Summary of Comments and Responses for the Central Contra Costa County Crossover

**San Francisco Bay Area Rapid Transit District
300 Lakeside Drive
Oakland, CA 94612**

February 20, 2006

Figure 7B
Site Plan – Southern Crossover – Option B

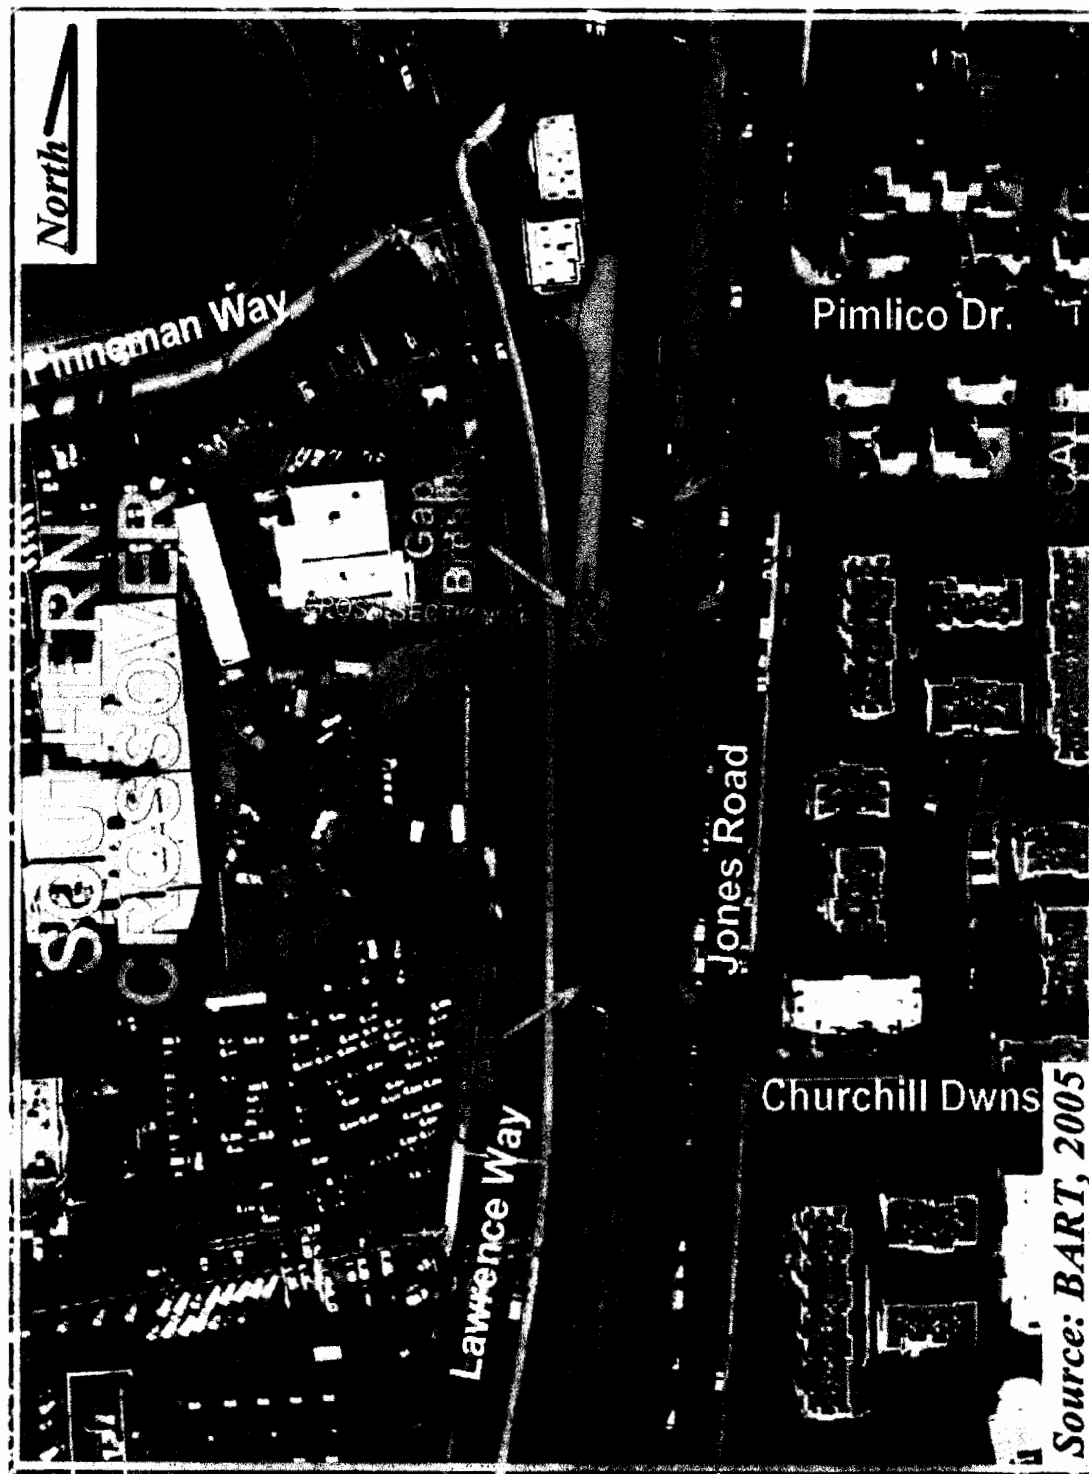
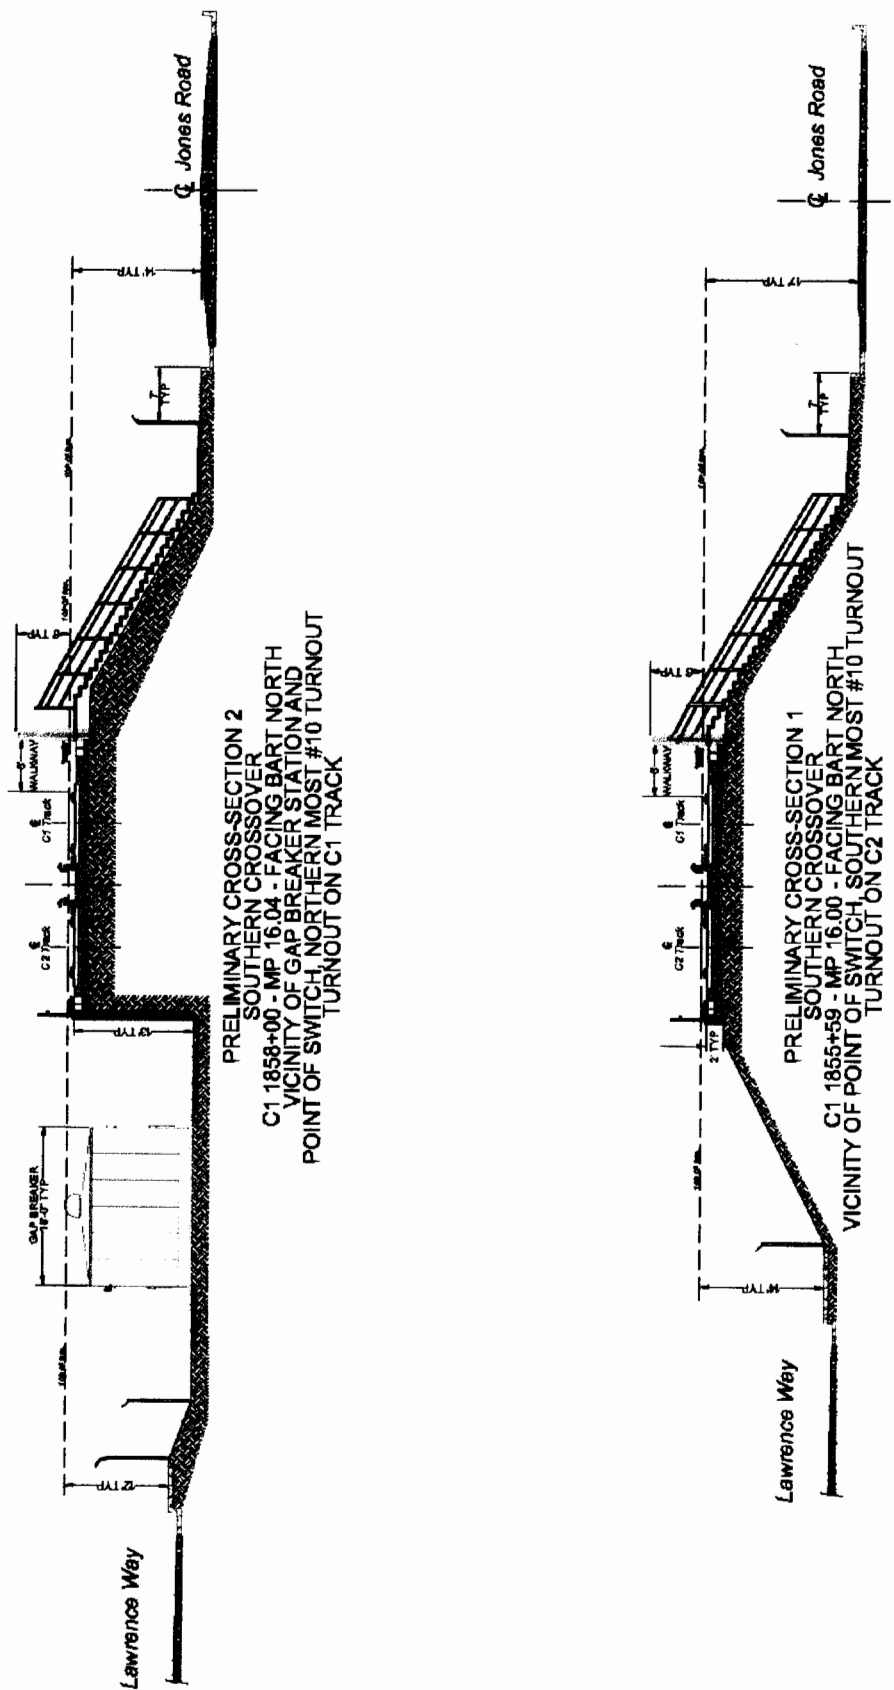
Some commenters questioned the need for the project or requested that the crossovers and/or gap breaker stations be relocated away from residences east of Jones Road.

In response to neighborhood requests, BART has investigated the possibility of relocating the gap breaker stations from the east (Jones Road) side of the alignment to the west side, which faces Lawrence Way and Interstate 680. Relocating the gap breaker station for the northern crossover is not feasible. There is not sufficient access to the property west of the alignment. The presence of Interstate 680 and the northbound exit lane from Interstate 680 to the Geary Road/Treat Boulevard interchange immediately west of the BART alignment precludes any attempt to provide BART access to the degree necessary to relocate the northern gap breaker station to the west side of the BART alignment. However, it may be possible to relocate the southern gap breaker station.

Moving the gap breaker station from the Jones Road side to the Lawrence Way side would remove some of the construction traffic related to the southern gap breaker station from Jones Road, but would not eliminate it entirely. (See construction responses below.) Under either option, the project would not have any unmitigated significant environmental impacts.
